### 3.4 Instrumentation and Control

STD DEP T1 3.4-1 (Figure 3.4a, Figure 3.4b, Figure 3.4c)

**Figure 3.4a Safety System Logic and Control (SSLC) Control Interface Diagram**

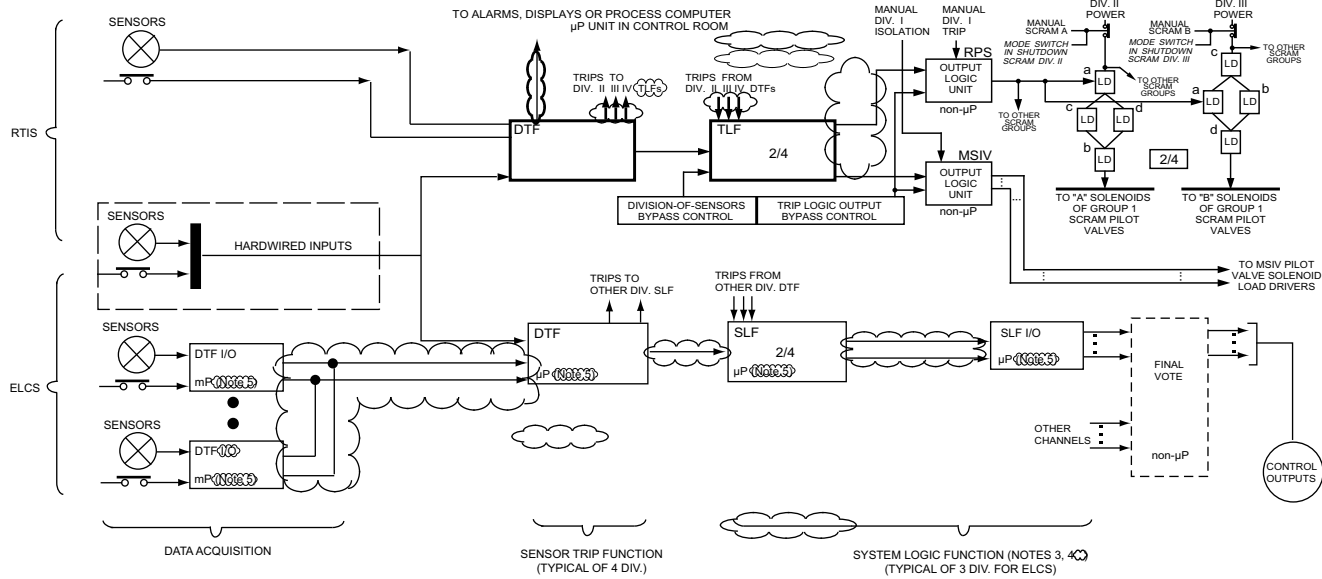
safety-related portions of the Neutron Monitoring System (NMS), the Containment Atmospheric Monitoring System (CAMS) and the radiation monitoring systems. The relationship between SSLC and systems for plant protection is shown in Figure 3.4a.

Figure 3.4b Safety System Logic & Control Block Diagram

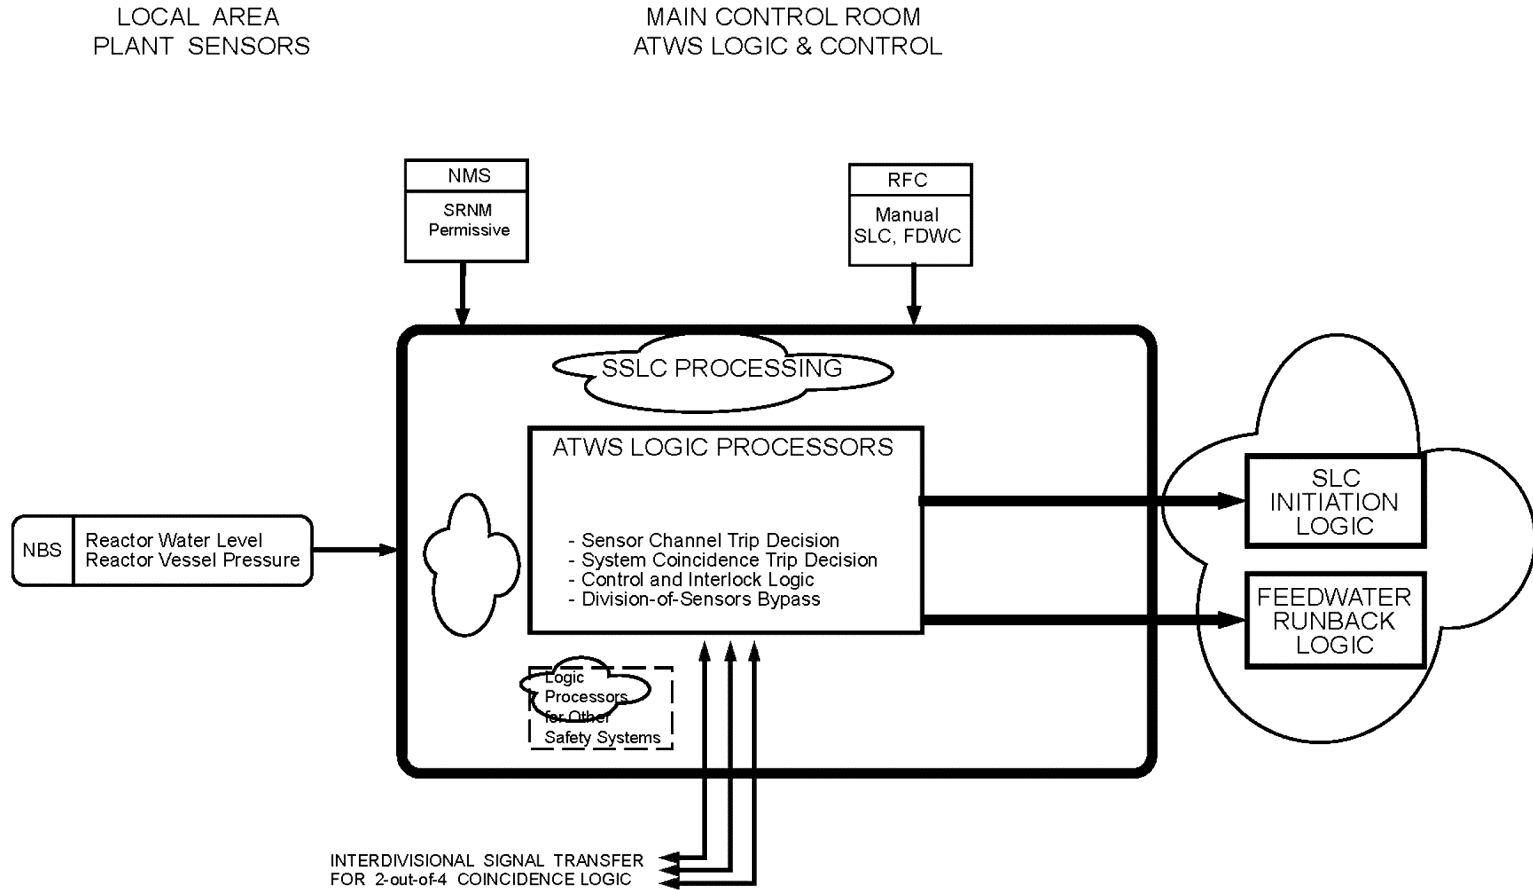
~~The basic hardware functional configuration for one division of SSLC is shown in Figure 3.4b. Each division runs independently (i.e., asynchronously) with respect to the other divisions. The following steps describe the processing sequence and associated function descriptions for incoming sensor signals and outgoing control signals. These steps are performed simultaneously and independently in each of the four divisions:~~

~~As shown in Figure 3.4b, a pair of SLU are located in each of two engineered safety feature (ESF) processing channels, ESF1 and ESF2. ESF1 processes initiation logic for functions which service the reactor vessel at low pressure (e.g. RHR), while ESF2 provides the same support for the vessel at high pressure (e.g. Reactor Core Isolation Cooling (RCIC) System and High Pressure Core Flooder (HPCF) System). Associated LDS and ESF functions are also allocated to these logic channels.~~
